LiDAR Quality Assessment Report

Project ID:
G11AC20072

Project Description:
OR_Sandy_River_2011

Figure 2.3 Selected RTK point images are NAIP orthophotos.

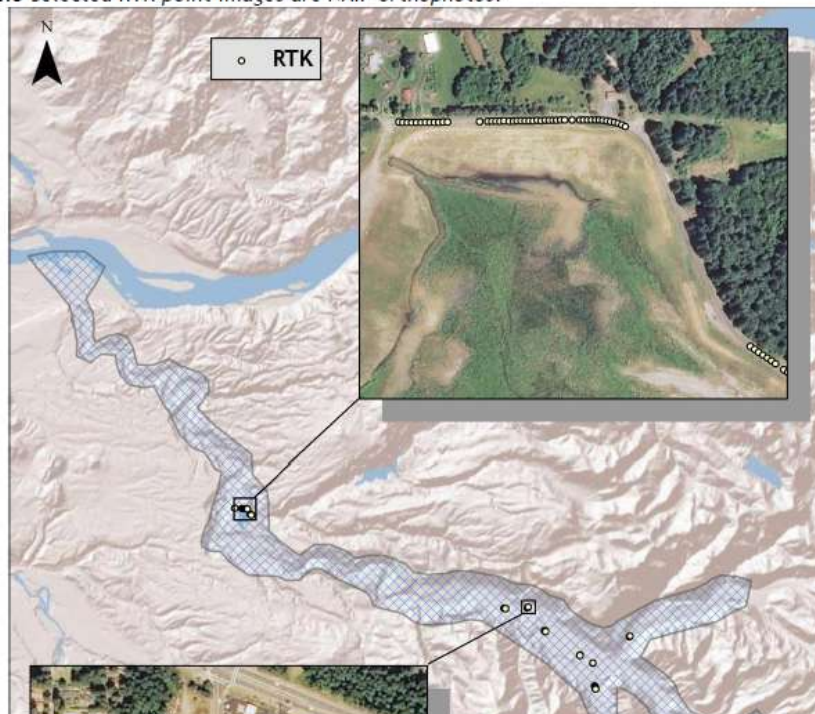
For data delivered to date, 193 RTK (Real-time kinematic) points were collected in the study area. **Figure 2.3** shows detailed views of selected RTK locations for all areas.

Contract does not reference USGS version 13 specs, therefore, no land cover class assessment was performed. Vertical accuracy was reported as RMSE 0.13 ft (0.04m). The sample size was 193 independent RTK points collected by DOGAMI.
